LIC-16-0011
April 4, 2016

Fort Calhoun Station (FCS), Unit 1
Renewed Facility Operating License No. DPR-40
NRC Docket No. 50-285

Subject: Notification of Alternative Implementation of REC-111 and REC-137 from the Original License Condition

OPPD's Evaluation of Alternative Implementation of NFPA 805 Proposed Modifications

Figure 1

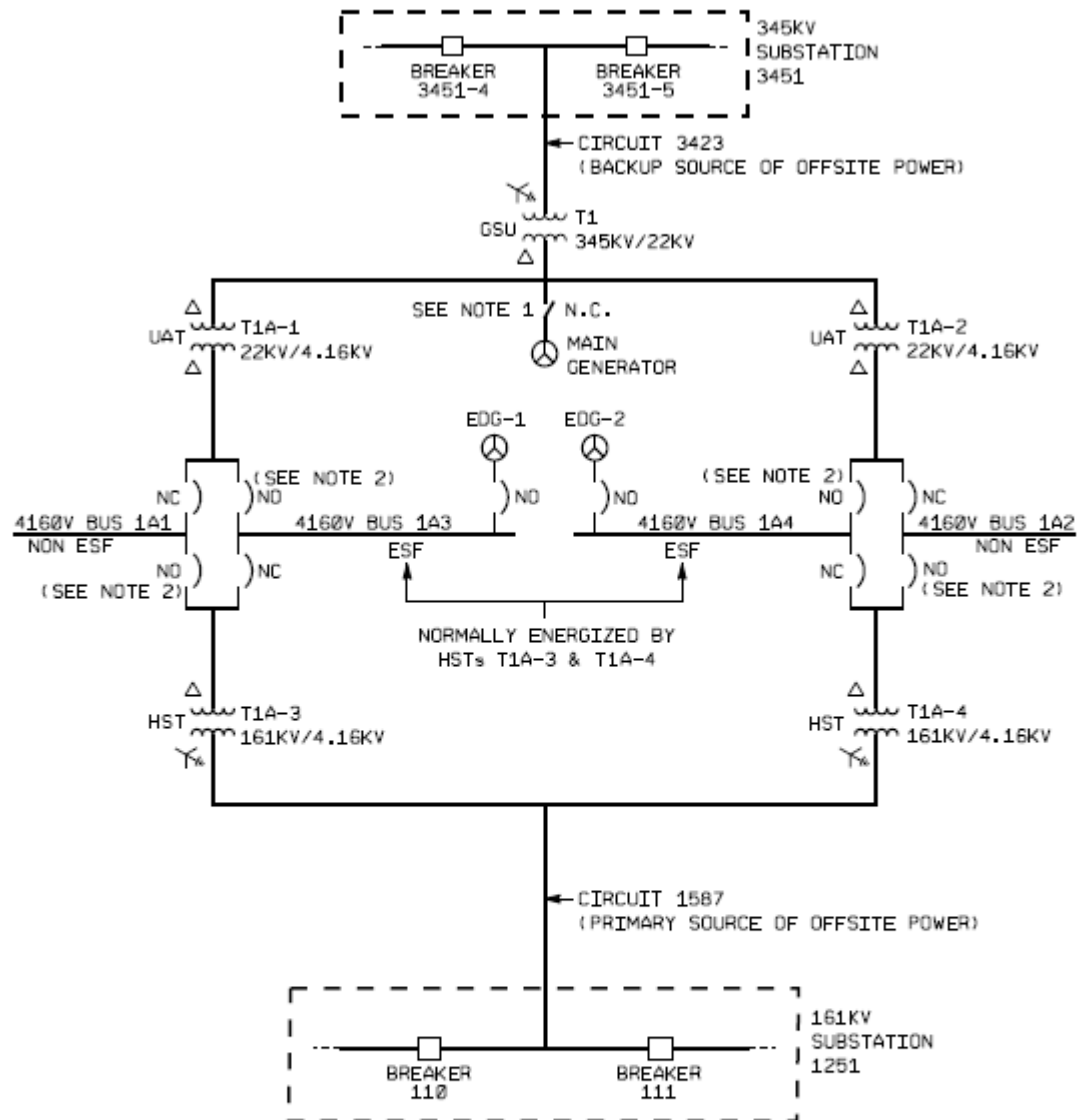
The 4160 VAC circuit breakers and associated cables that control the alignment of offsite power to buses 1A3 and 1A4 are located in the switchgear rooms and are separated by train. High voltage circuit breakers located in the switchyard can be controlled from the main control room via cables that are currently routed through both switchgear rooms, i.e. through both fire areas 36A and 36B. Refer to the attached one-line diagram, Figure 1, for additional details regarding the layout of the FCS electrical distribution system.

The alternative modification, EC 58160 (Reference 3.15), will re-route selected cables so that a HEAF and subsequent fire occurring in either switchgear room would not impair the capability of operators to restore offsite power. The modification would re-route cables associated with the control of switchyard breakers so that they would not be impacted by the postulated HEAF. In a worst case HEAF scenario, it would be possible for offsite power to be lost due to actuation of protective relays. However, with the offsite power control cables re-routed, offsite power restoration to the unaffected train would be possible during an event occurring in either switchgear room. This alternative modification would also revise plant fire procedures to provide guidance to operators for isolating the fault and restoring offsite power to unaffected buses.

The alternative modification to the installation of HEAF shields will re-route switchgear room cables associated with the control of switchyard breakers that may require operation from the control room to restore offsite power after a HEAF or switchgear room fire. The change will also add isolation fuses to ensure that the fire does not cause switchyard breakers to lose credited control power due to damage to components located in the switchgear rooms. These changes will ensure that, for certain damage scenarios in fire areas 36A or 36B resulting from HEAF or fire, offsite power can be restored.
